**AR 21-0018**

**Walgraev Industrial Park (Hedges  
Creek)**

**ARCHITECTURAL REVIEW BOARD**  
**June 29, 2022**

# Site Design (TDC 73A)

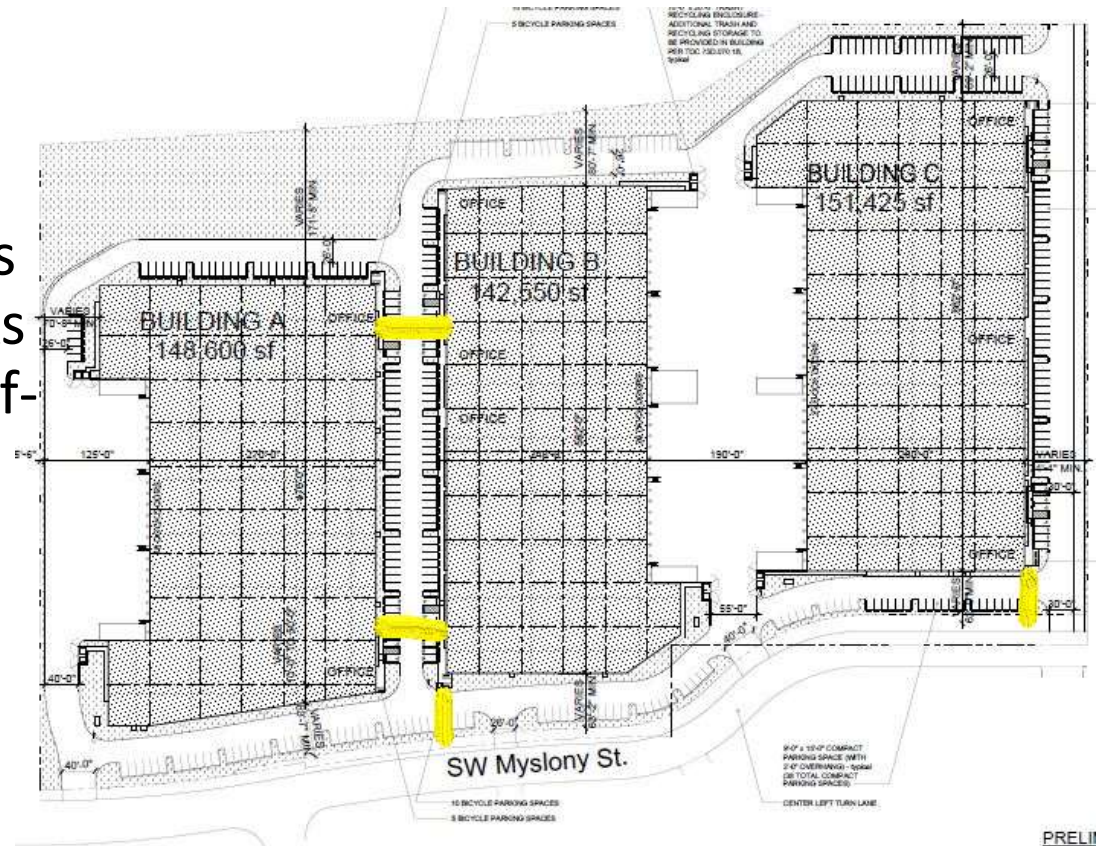
With conditions, the proposal complies with TDC 73A.500(1):

- Provide walkways between main buildings entrances and sidewalks along the public right-of-way;

# Site Design (TDC 73A)

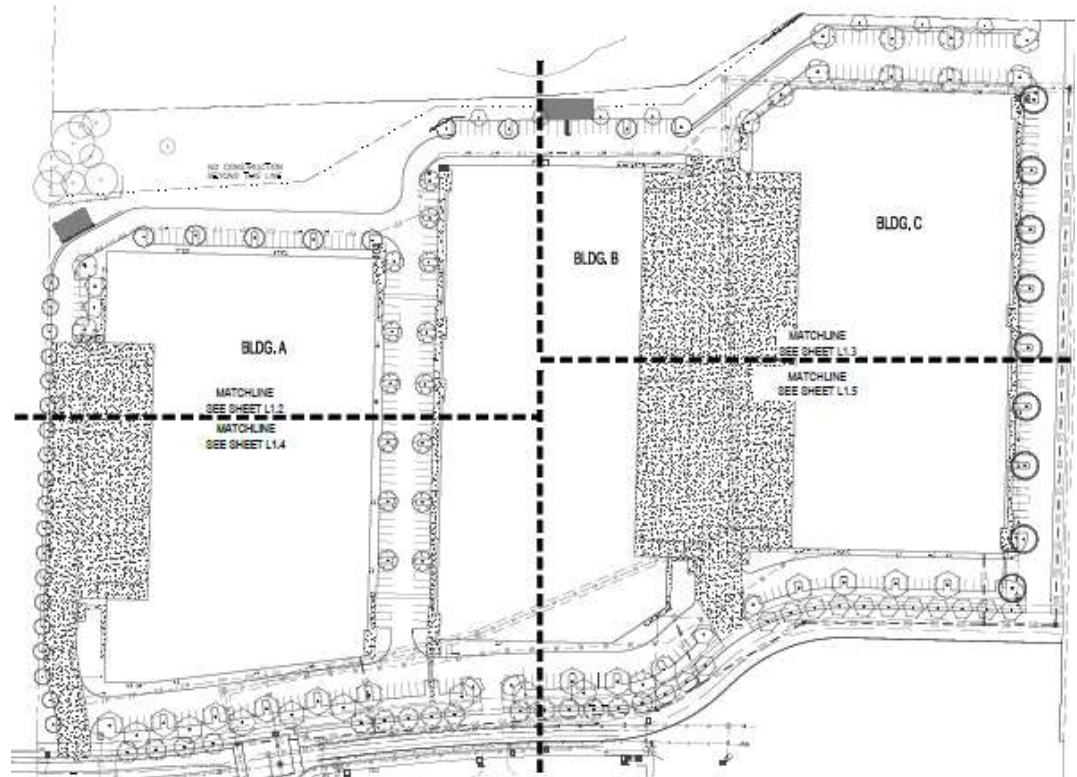
**With conditions, the proposal complies with TDC 73A.500(5):**

- Provide an updated landscaping plan that utilizes evergreen or conifer type trees to provide year round screening for loading dock areas.

# Parking Standards (TDC 73C)

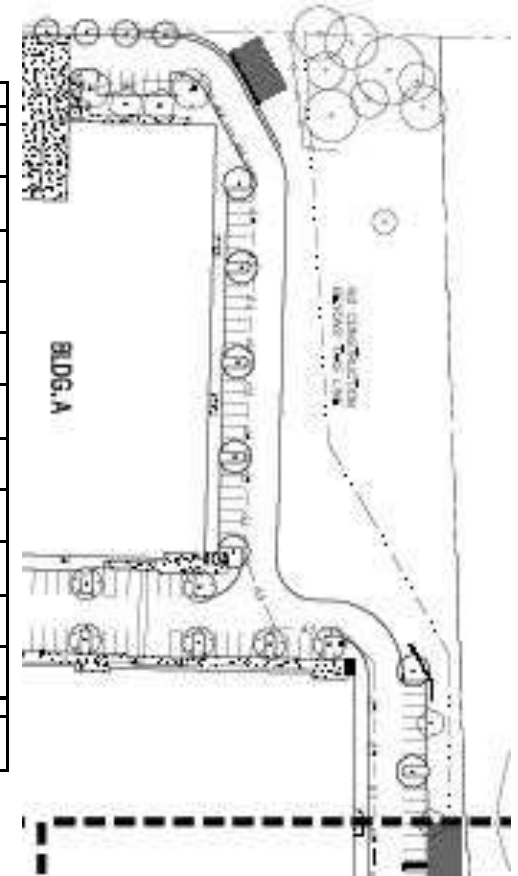
**With conditions, the proposal complies with TDC 73C.240(4):**

- Must be planted with one deciduous shade trees for every four parking spaces; Required trees must be evenly dispersed throughout the parking lot

- **TDC 74.630. - Storm Drainage System.**

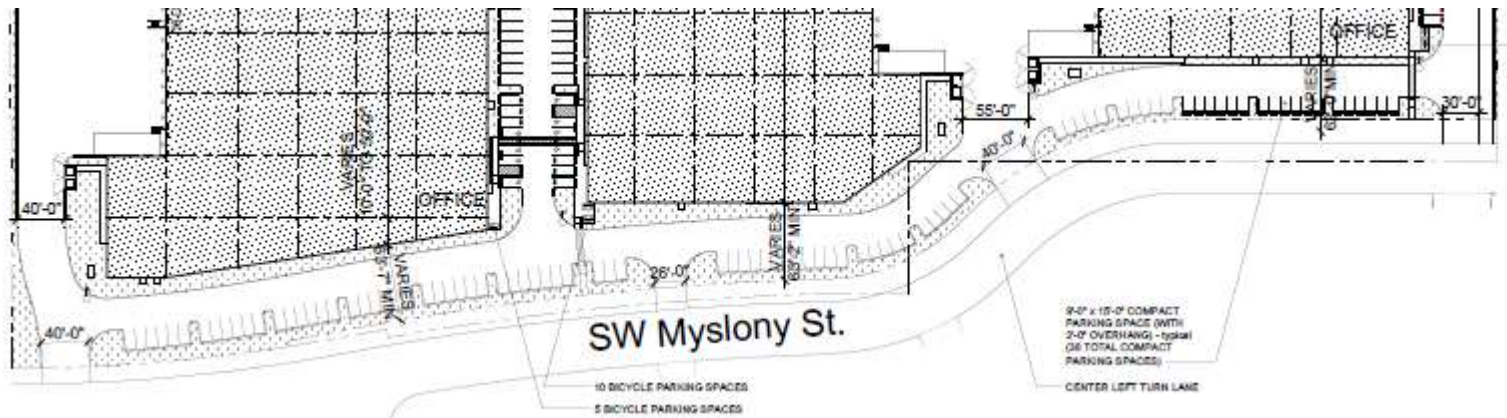
**With conditions, the proposal will require compliance with both the City and CWS storm drainage requirements, or an acceptable alternative.**

Storm drainage near the north end of the site will be treated by vegetated corridor as filter strips with most of the impervious area by Bio-Clean's stormwater biofiltration system vaults. Underground detention systems will assure the overall site release rates match pre-development up to the 25-year storm event and hydromodification requirements. Some locations are unable to be detained due to topography but equivalent detention will be provided where possible.
